A. M. HUNTER,
CARPENTER AND BUILDER.

April 21st 1898

Mr Wm. H. Messerum
Dear Sir

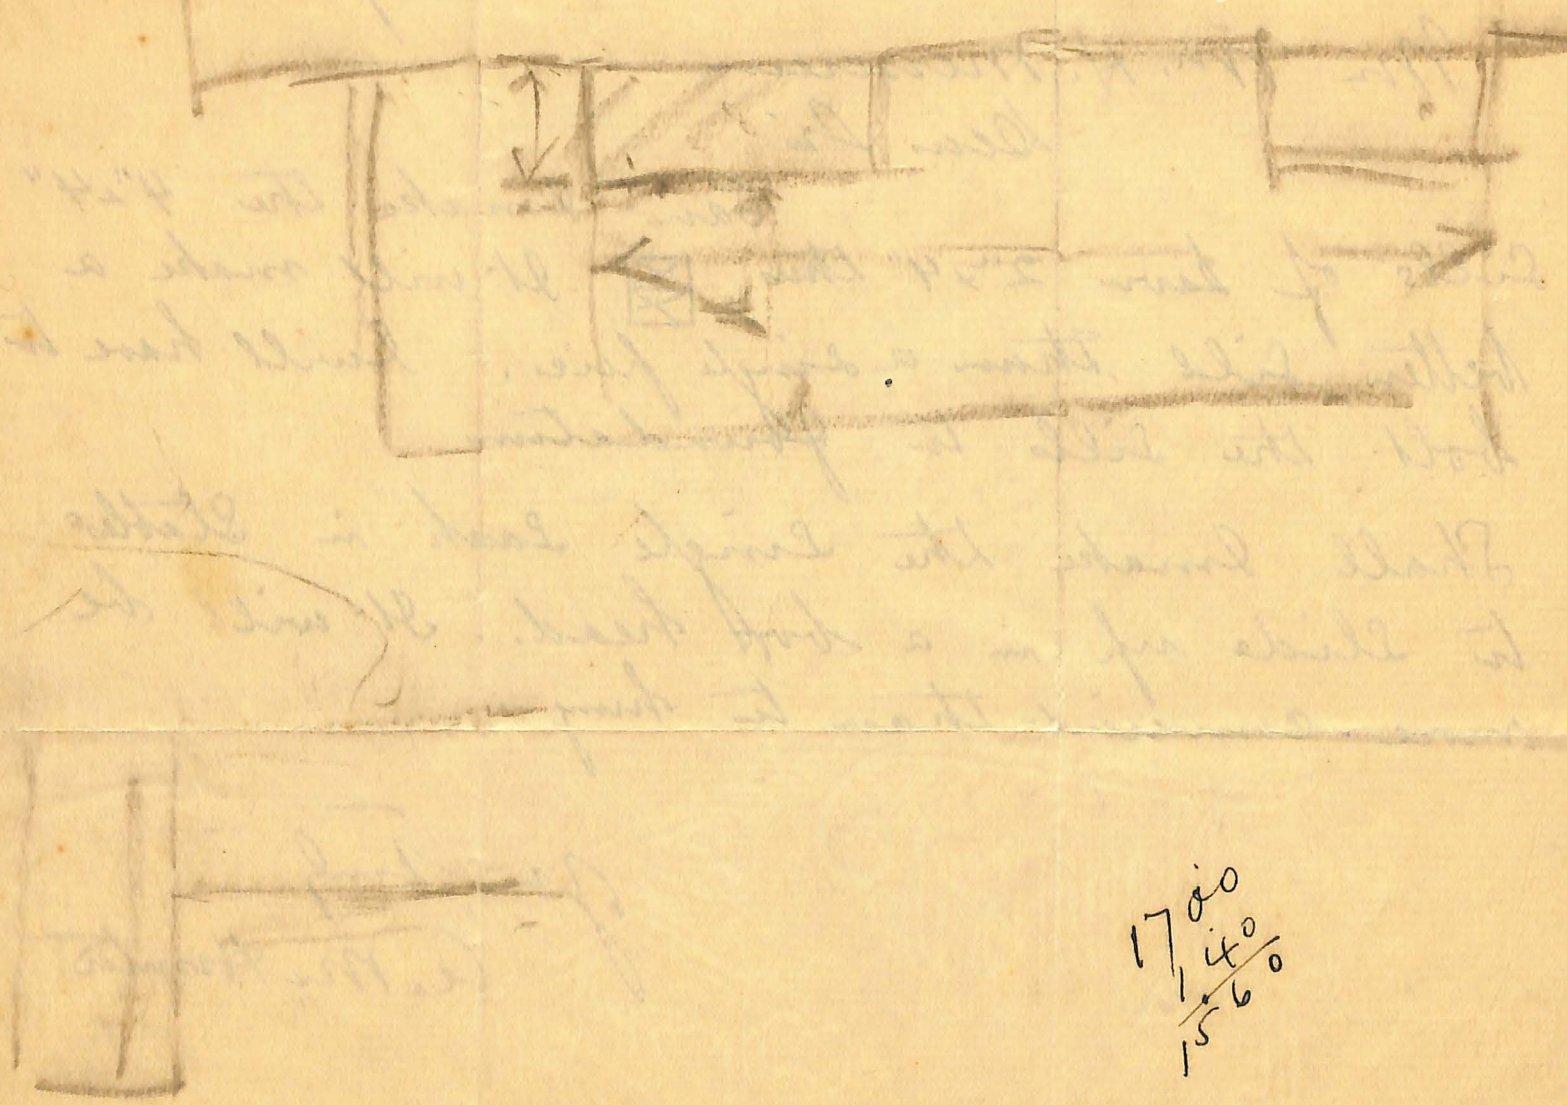
Can I make the 4"x4"
Sills of two 2"x4" thus . It will make a
better Sill than a single piece. I will have to
bolt the Sills to foundation
